COMMONS SLOPED ROOF FRAMING PLAN - AREA "A"

CHRISTWOOD
A CONTINUING CARE RETIREMENT FACILITY
COVINGTON LOUISIANA

S2.2

3 SECTION
1/8" = 1'-0"

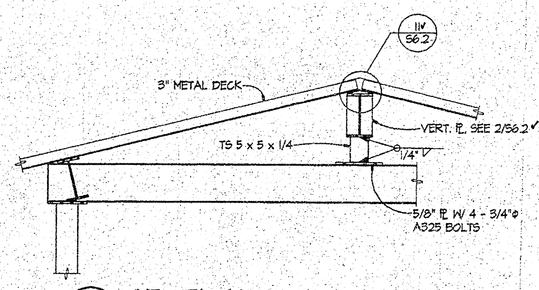
Delete detail 3/S2.2 - per Add F

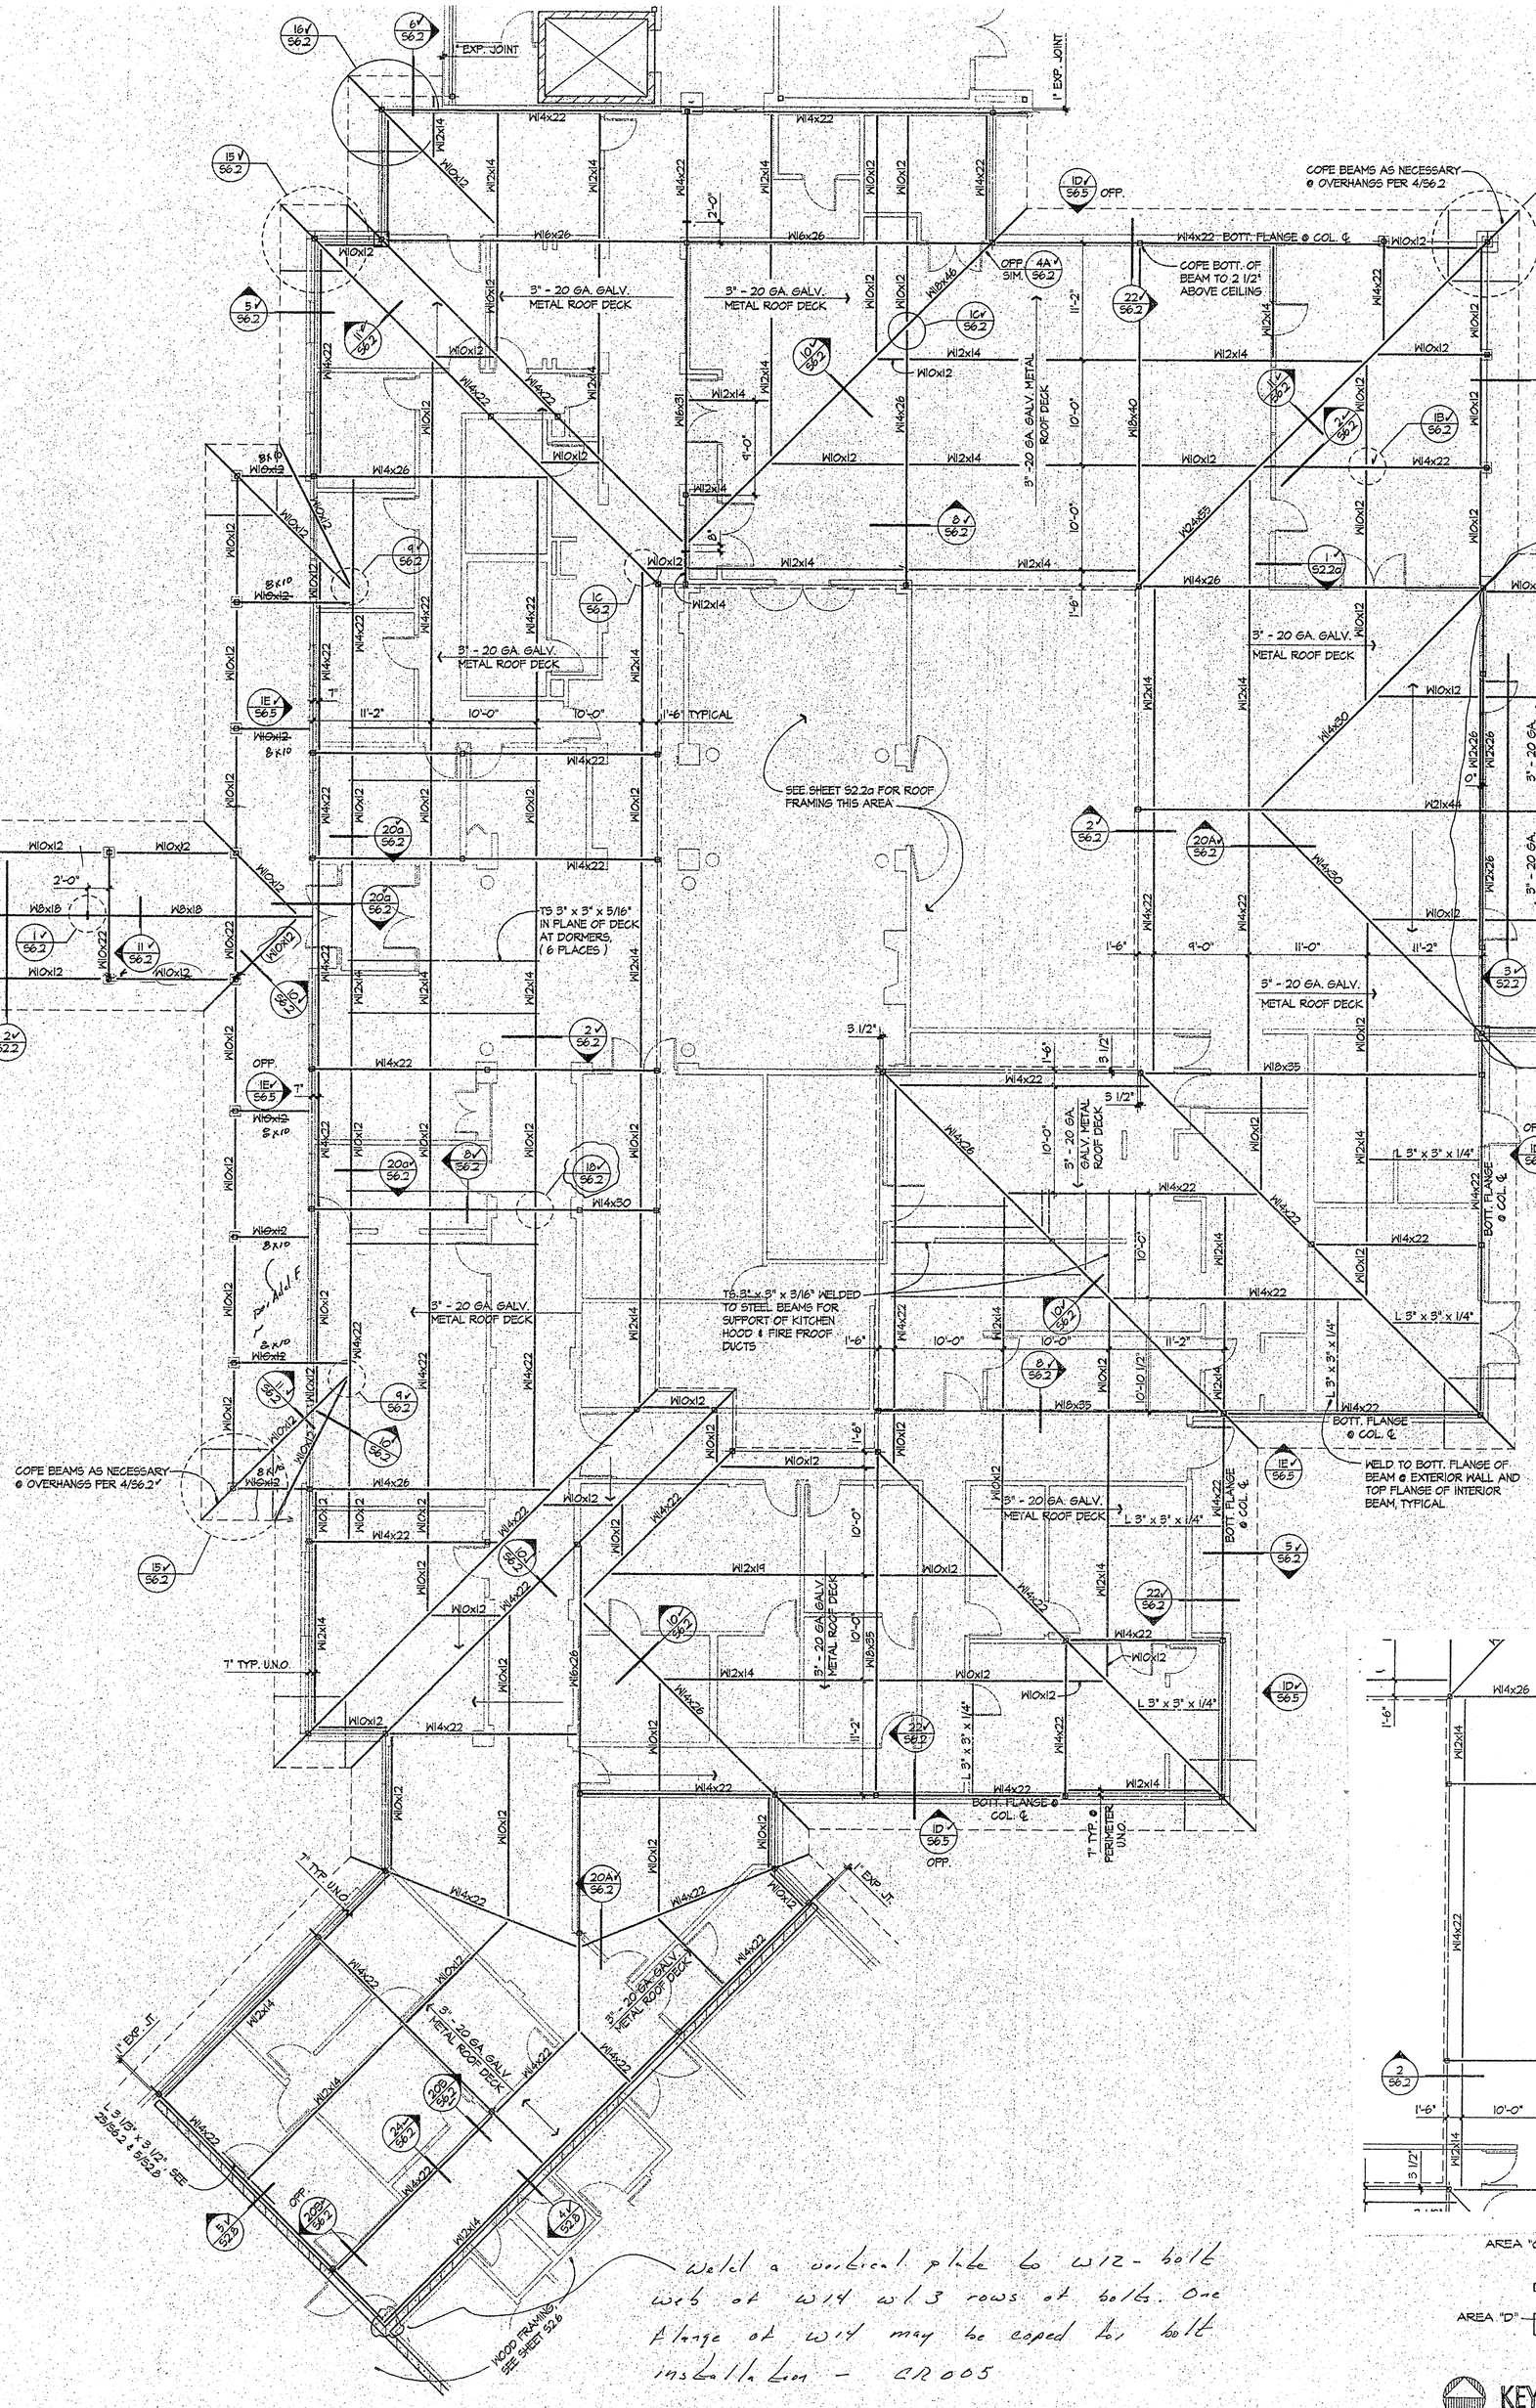
Delete roof over patio at central clerestory framing per S6-S2.5 - Add F

Weld a vertical plate to W12 - bolt web of W14 w/ 3 rows of bolts. One flange of W14 may be coped for bolt installation - CR005
